Rezoning Application: PD 22-0565
Zoning Hearing Master Date: August 15, 2022
BOCC Land Use Meeting Date: October 11, 2022

REVISED REPORT

APPLICATION NUMBER: PD 22-0565

MPA DUPLEX DEVELOPMENT
1511 SE 3RD AVENUE
RUSKIN, FLORIDA
PD PLAN

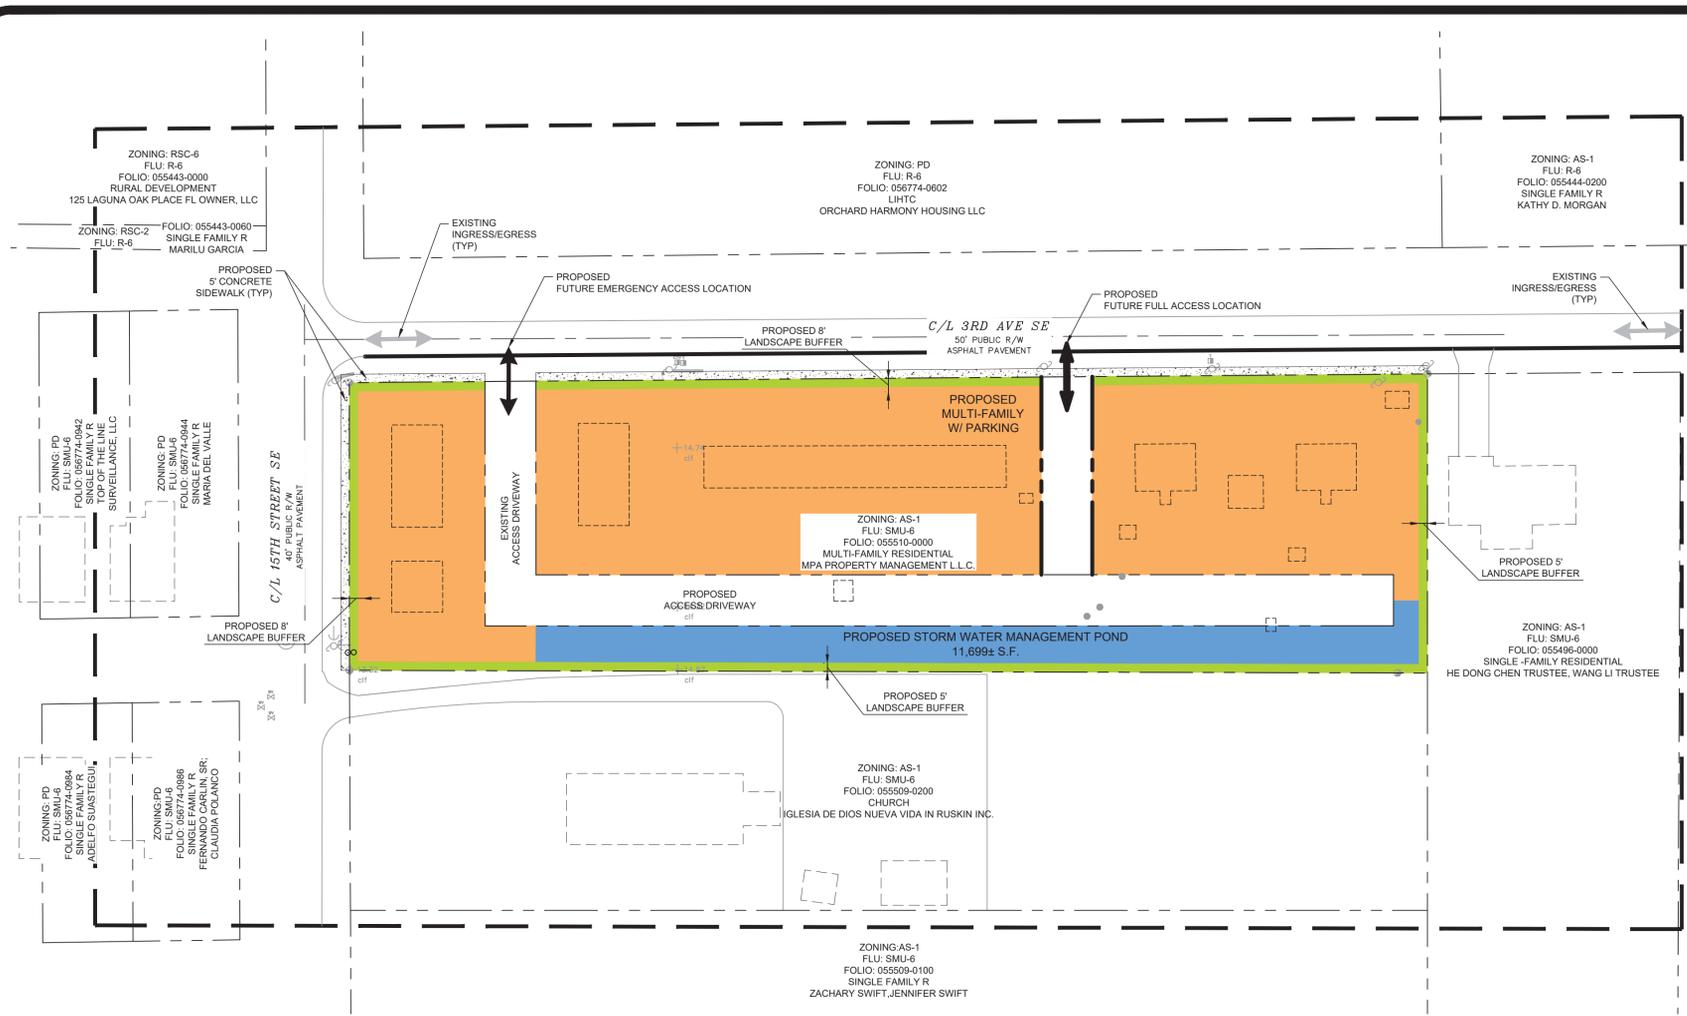
- Prior to PD site plan certification, the developer shall revise the site plan to:
 - On the Phase 1 plan sheet, label the existing driveways as "Existing Driveway to Potentially Remain – See Conditions of Approval";
 - Replace the Sheet 1 name, which is illegible with a title reading "Phase 1 PD Plan";
 - Replace the Sheet 2 name stating "PD Plan" to read "Phase 2 PD Plan";
 - On Sheet 2, replace the label stating "Proposed Future Emergency Access Location" with a label reading "Existing Access Vehicular and Pedestrian Access to be Converted to Gated Emergency Only Access with Knox Box and Pedestrian Connection".

- On Sheet 1, revise Note 8 to state “Project driveways will be privately maintained and shall not be gated.”
- On Sheet 2, make the following modifications to the “Notes” section:

- Revise Note 4. Staff understood from speaking with the applicant’s agent (and proposed conditions indicate) that Phase 2 redevelopment may occur in phases. Please revise the note accordingly.

- Delete Note 6. Staff understands in speaking with the applicant’s agent that redevelopment will occur in phases, and that the redevelopment of one building will not require removal of all existing structures.

- Revise Note 9. Internal transportation facilities are labeled as driveways and not roadway. Staff notes that the internal facility does not appear to be wide enough to meet TTM requirements, and as such could not be constructed to roadway standards. Please revise the note to state “Internal driveways and sidewalks will meet requirements of the Hillsborough County Land Development Code (LDC) and Transportation Technical Manual (TTM) and shall be privately maintained.”

- Revise Note 10. There is insufficient room to gate every existing access. Replace the existing note with a note reading “The emergency access connection will be gated with a Knox Box. The main project access may be gated. If gated, the access will comply with TD-9 standards per the Hillsborough County Transportation Technical Manual.”

- Replace Note 16 with a note stating, “Parking to be provided in accordance with Section 6.05 of the LDC and as required in the conditions of approval.”
